UDP800 MKII

IMPROVEMENT

UDP900 MKII

HDMI AUDIO Port of Mainboard

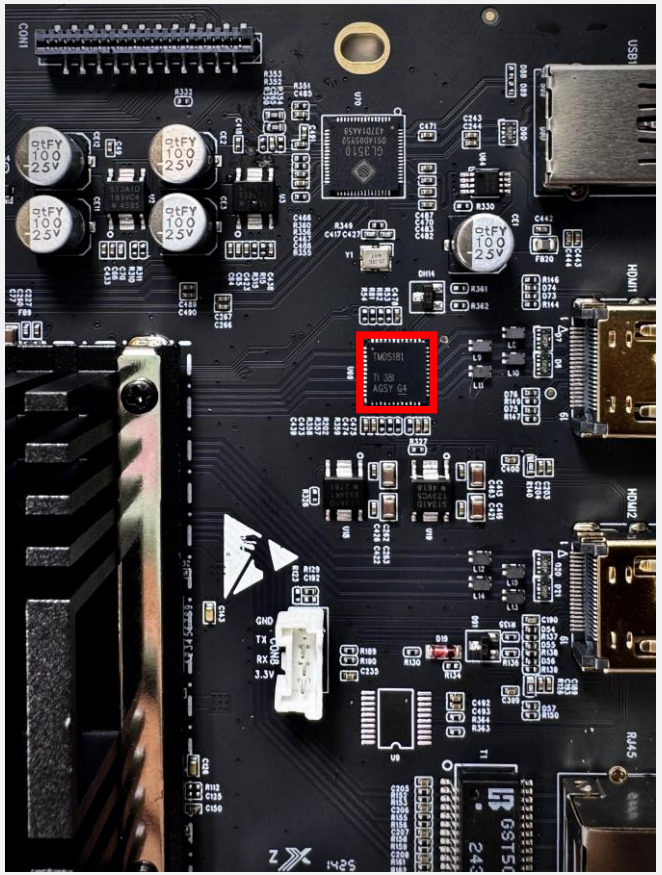
Adding the TMDS retiming function to the mainboard’s HDMI AUDIO port, which can effectively compensate for random jitter, provide better signal quality and load-carrying capacity, and further improve the HDMI audio quality, making the sound details richer.

Optimization of USB3.0 Port

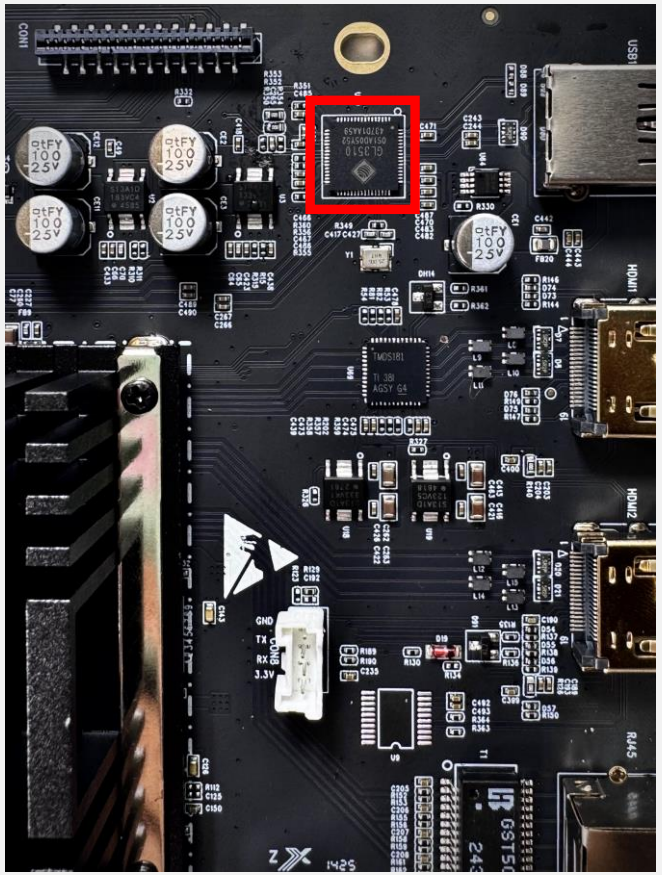
Add a USB3.0 HUB chip and redesign the USB3.0 power supply to improve the compatibility and stability of the USB3.0 port, so as to better adapt to USB flash drives and hard drives. The optimization also enhances the stability of data transmission and increases the transmission speed, thus achieving better sound and picture effects.

Operational Amplifier

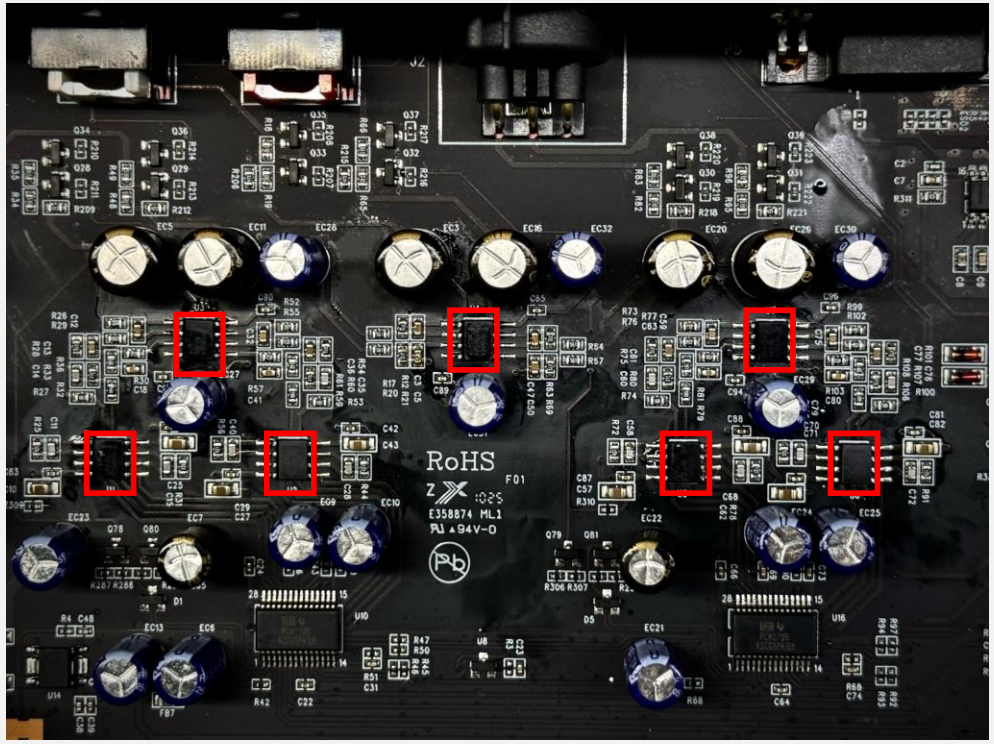
Replacing the operational amplifiers with seven OPA1602s. Its low noise reduces audio distortion for clearer sound. High precision ensures accurate signal reproduction, creating audiophile-grade sound.

Optical Drive Structure

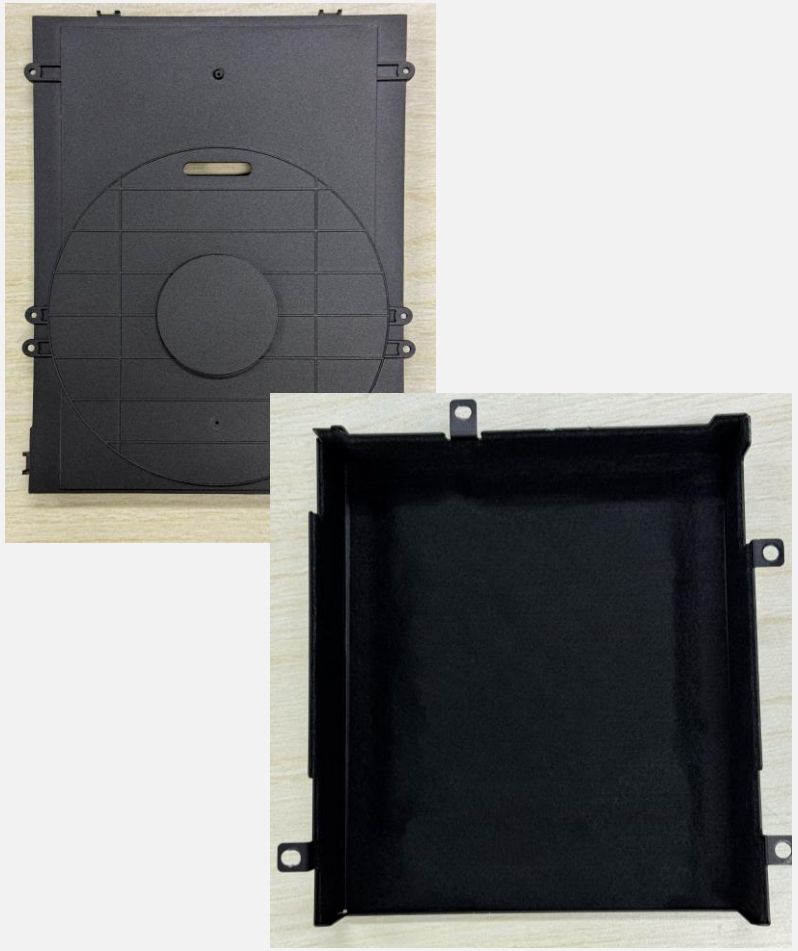
The frame is spray-painted, and add sound-absorbing cotton to the drive's outer casing, enhancing durability and reducing noise.

Optimization of USB3.0 Port

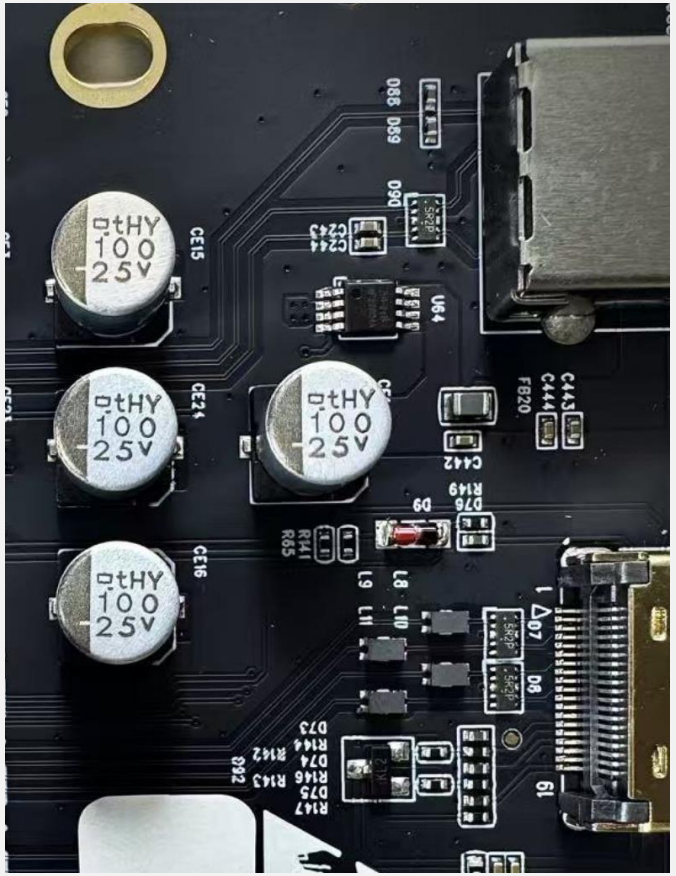
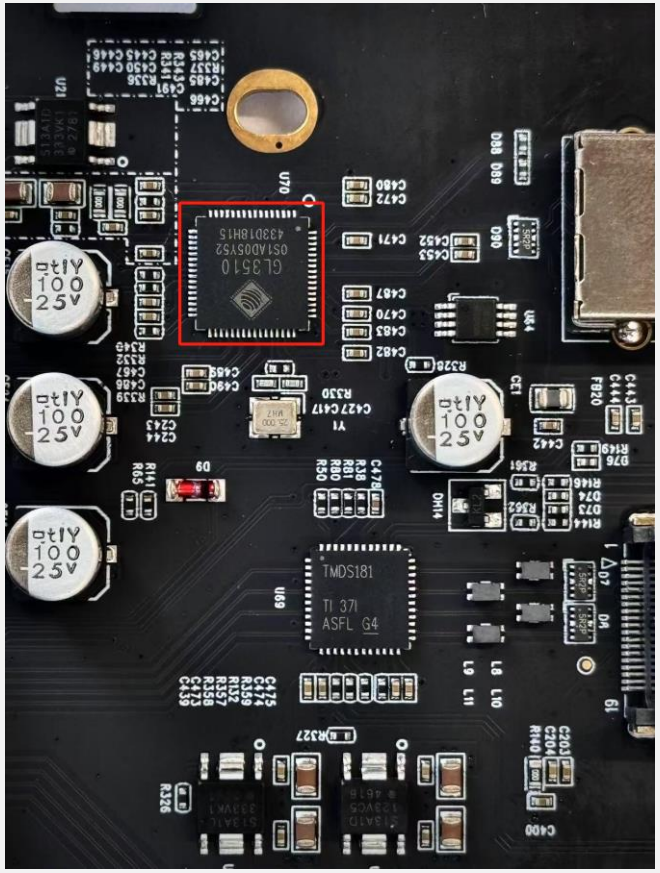
Add a USB3.0 HUB chip and redesign the USB3.0 power supply to improve the compatibility and stability of the USB3.0 port, so as to better adapt to USB flash drives and hard drives. Also enhances the stability of data transmission and increases the transmission speed, thus achieving better sound and picture effects.

7.1-channel DAC

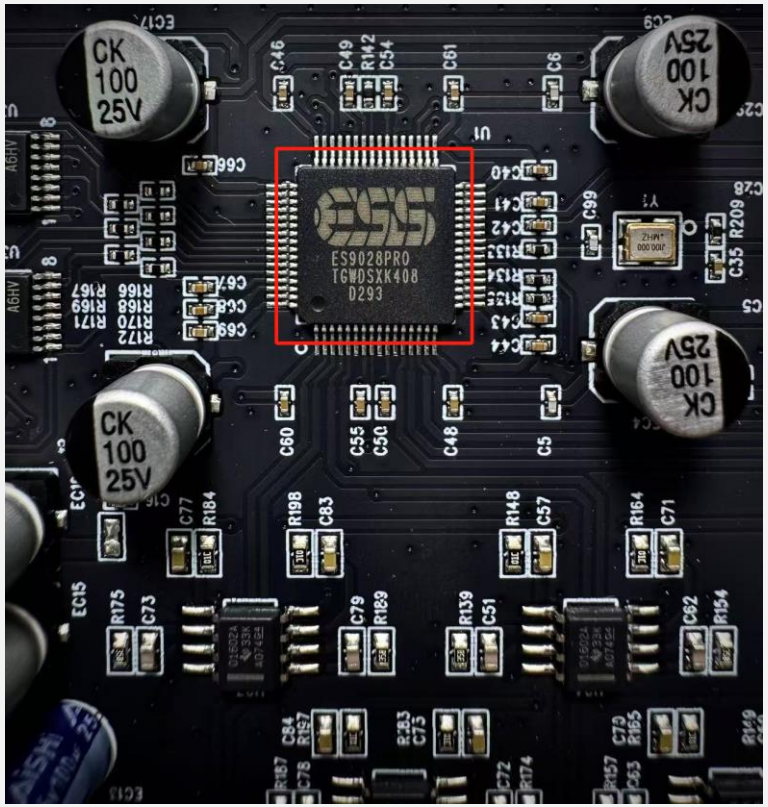
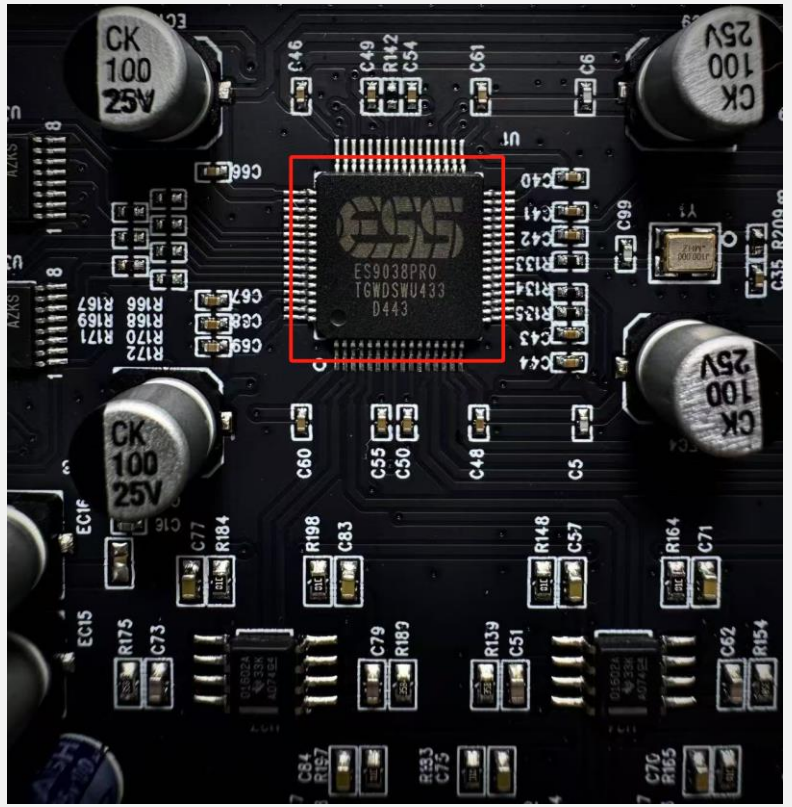
Upgrade the 7.1-channel DAC from ES9028PRO to ES9038PRO, improve the audio decoding ability, and bring more excellent surround sound effects and sound quality performance.
